Access Compliance Report

Public Rights-of-Way

Intersection ID: 16837	Main Street: CEDARWILD_RD	Cross Street: ELM_FOREST_DR	Location:	S
ADA ID: C6E3984A3E15	Ramp Type: Directional1	Initial Pass/Fail: Fail	Overall Compliance: No	Severity Score: 10

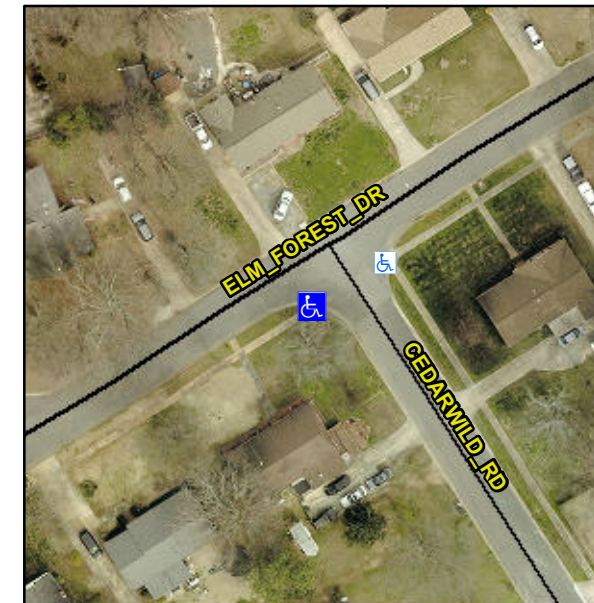
R304.5.1, R304.5.3

Compliance	Description	Data	Compliance	Description	Data
N/A	Ramp Length (in)	67.0	N/A	Grade Break?	N/A
No	Ramp Width (in)	47.0	N/A	Grade Break Slope (%)	0.0
Yes	Ramp Slope (%)	8.2	N/A	Grade Break XSlope (%)	0.0
No	Ramp XSlope (%)	4.2			
N/A	Flare Type LT	N/A	N/A	Flare Type RT	N/A
N/A	Flare Slope LT (%)	N/A	N/A	Flare Slope RT (%)	0.0
N/A	Flare Traversable LT?	N/A	N/A	Flare Traversable RT?	N/A
N/A	Landing Length (in)	0.0	N/A	DWS Provided?	N/A
N/A	Landing Width (in)	0.0	N/A	DWS Contrast?	N/A
N/A	Landing Slope (%)	0.0	N/A	DWS Length (in)	N/A
N/A	Landing X Slope (%)	0.0	N/A	DWS Full Width?	N/A
N/A	Landing Curb? (Y/N)	N/A	N/A	DWS Offset LT (in)	N/A
N/A	Shared Landing?	N/A	N/A	DWS Offset RT (in)	N/A
N/A	Gutter Ponding?	0.0	N/A	Gutter Slope (%)	N/A
N/A	Gutter Lip Ht (in)	0.0	N/A	Gutter X Slope (%)	N/A
N/A	Painted X Walk1?	No		Road Slope (%)	0.8
	X Walk 1 Direction	To NE		Road X Slope (%)	2.2
	X Walk 1 Width (in)	N/A		Clear Space?	N/A

X Walk 1 Slope (%)	0.8	N/A	Clear Space to XWalk (in)	N/A
	X Walk 1 X Slope (%)	2.2	N/A	Storm Grate/Utility Hazard?	N/A
N/A	Ramp inside XWalk1?	N/A		Storm Grate/Utility Type	
N/A	Any Obstructions?	N/A			N/A
	Obstruction Type		Yes	Surface Condition? (G/P)	Good
			N/A	Curb Slope (%)	16.5

Remove & Replace Entire Ramp.
